Preliminary responses to OEH and SEWPaC comments on the Preferred Project
Report and Response to Submissions — biodiversity (26 March 2013)

Re: Cobbora Coal Project – Preliminary Responses to OEH and SEWPaC Comments on the Preferred Project Report and Response to Submissions – Biodiversity

DATE: 19/3/2013
MEMO TO: Department of Planning and Infrastructure – Stephen O’Donoghue
FROM: Gavin Heydon
SUBJECT: CLARIFICATION OF TAILINGS INFORMATION
REFERENCE:

The purpose of this addendum is to correct the results presented in Appendix E that were affected by a water balance model error, and to discuss the wider implications of the error for the Surface Water Assessment and Environmental Assessment. In addition, further information is provided in the addendum on additional model sensitivity analyses undertaken to address a concern of the DP&I's reviewer regarding the reliance of the mine on the surface water entitlement from the Cudgong river source. Specifically, the reviewer raised the concern that the volume of groundwater inflow to the mine pits available for use in the mine water management system may have been overestimated.

Figure A4.1 – Water balance for SD9 for mine stage year 4 and 10th percentile rainfall (dry) year of 1967 (plot 1 of 3)

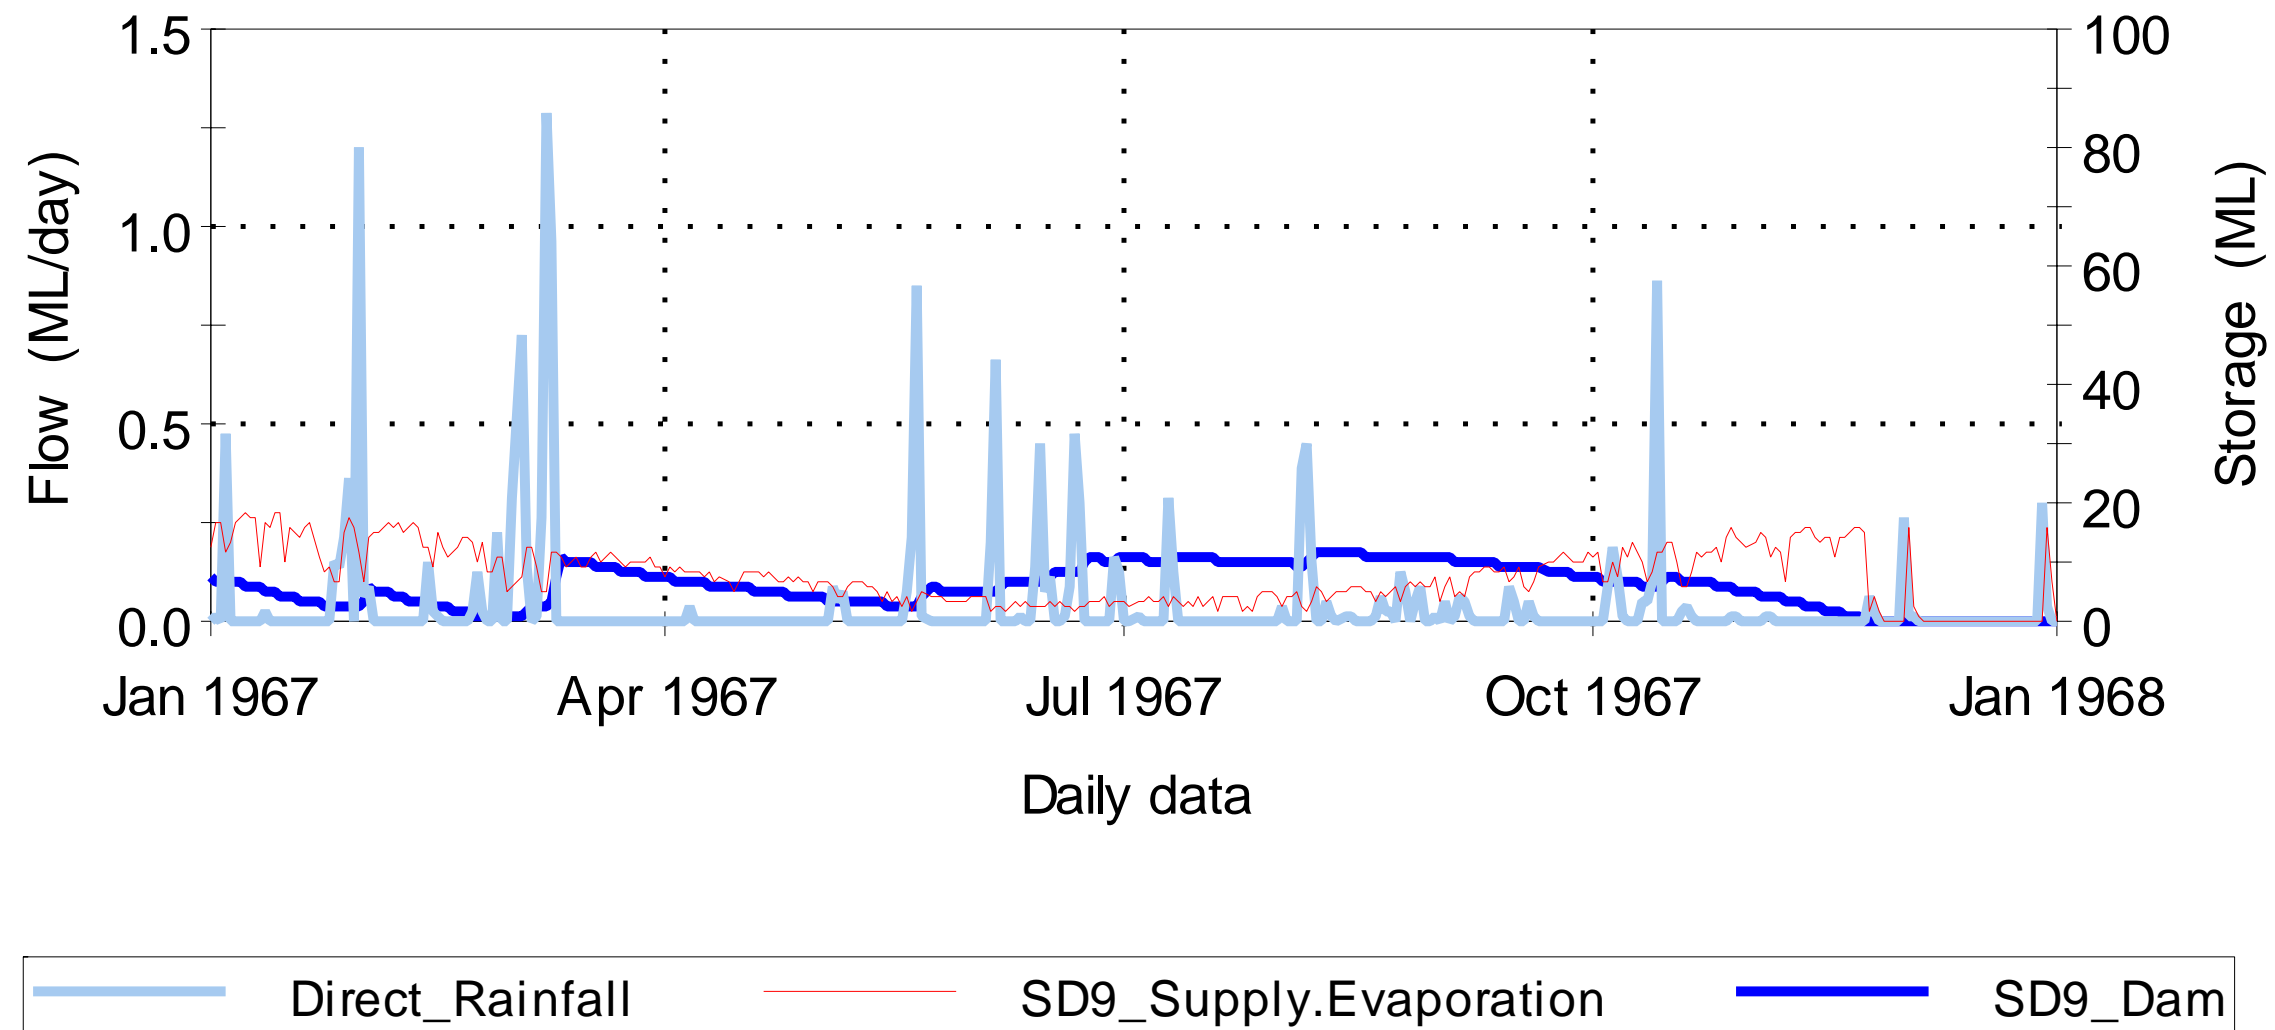
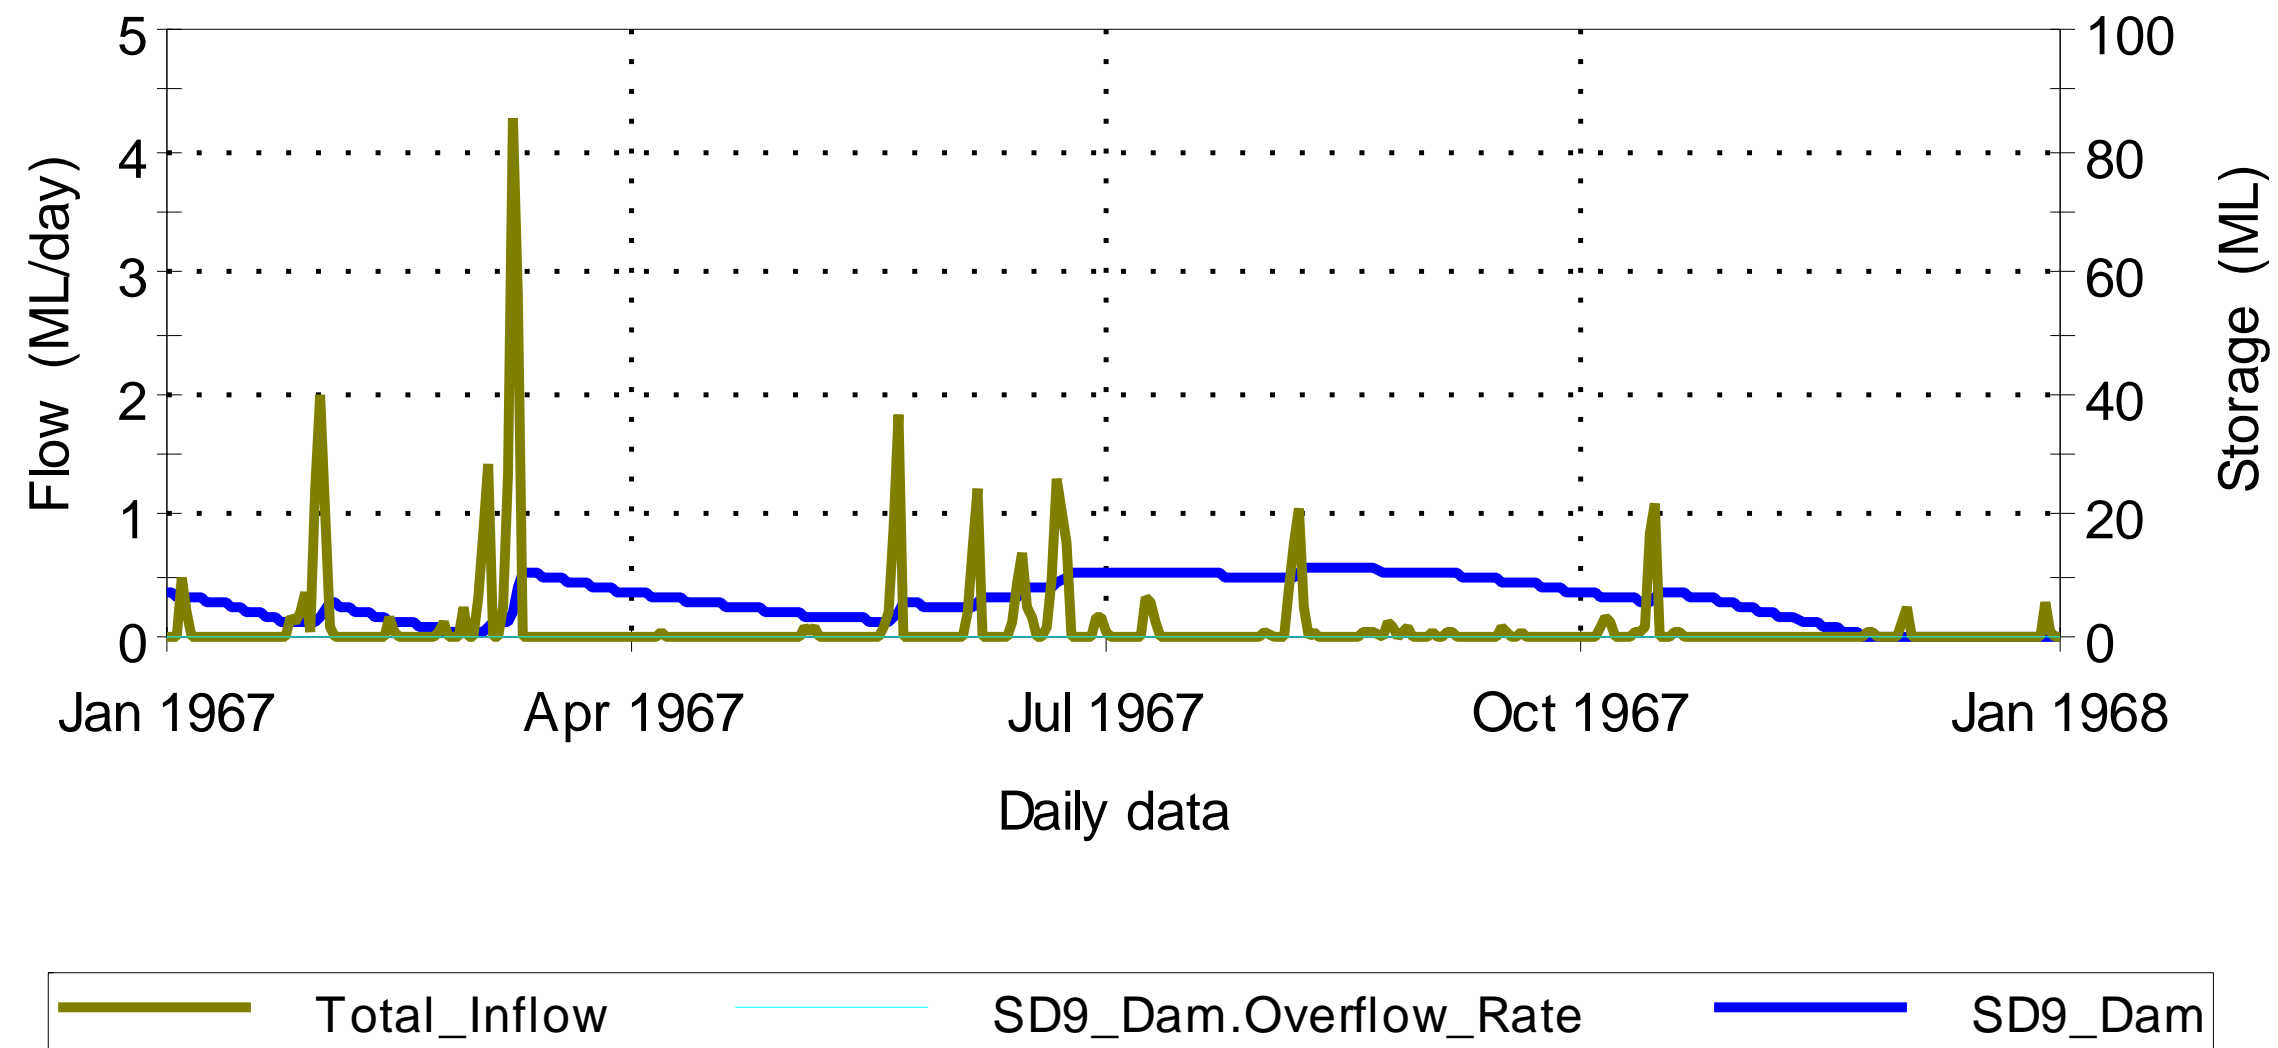
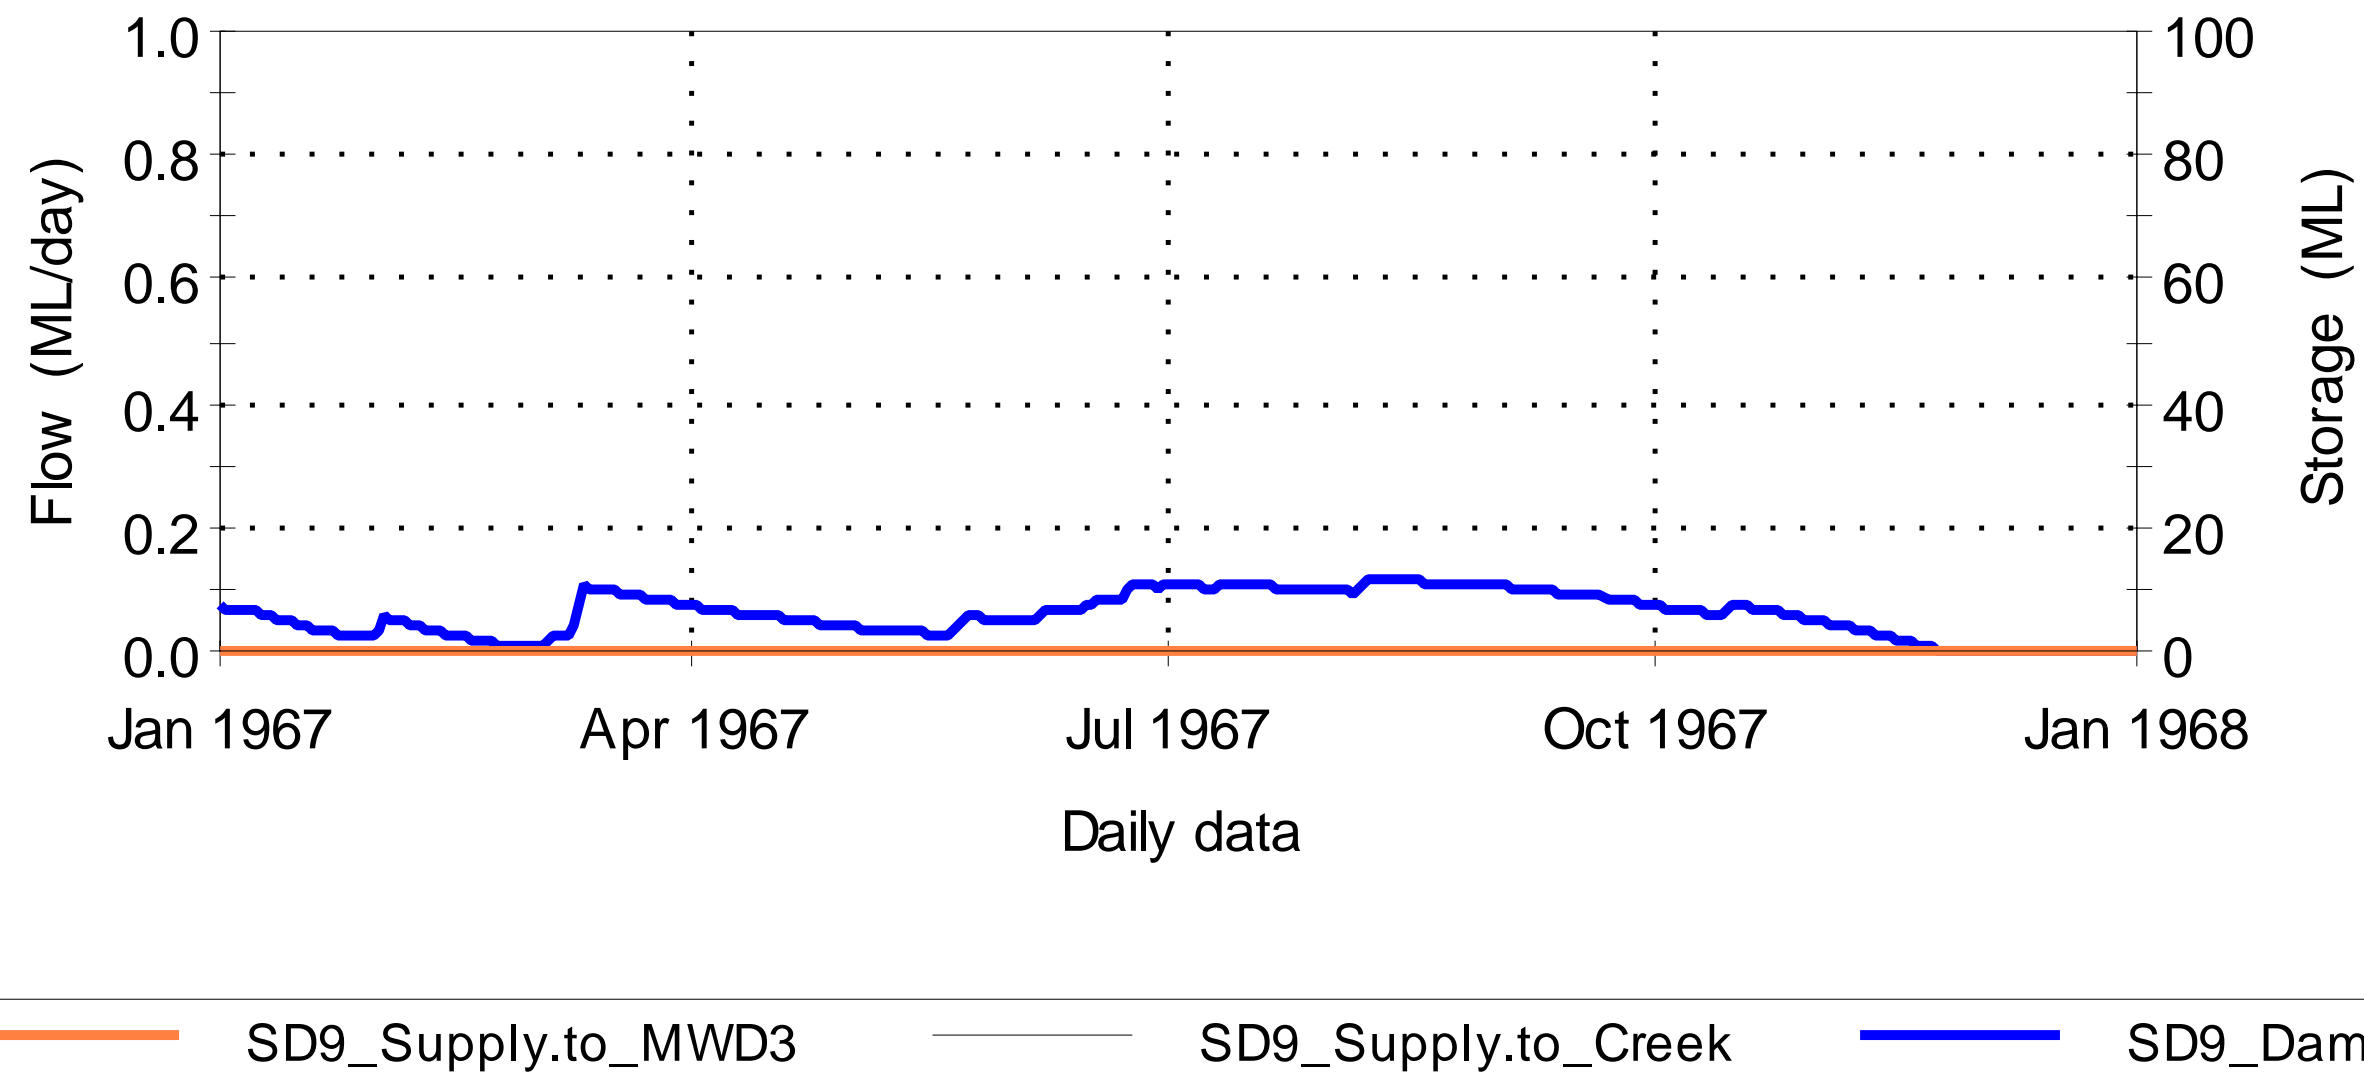
Figures A4.1 to A4.3 show the daily simulation for SD9 for 1967 (dry) conditions. These figures illustrate that the dam storage reduced to near zero multiple times. Supply from this dam did not occur to the creek or to MWD3 during 1967 as the water stored in the dam did not exceed the pipe outlet level, and because MWD3 was more than 25% full.
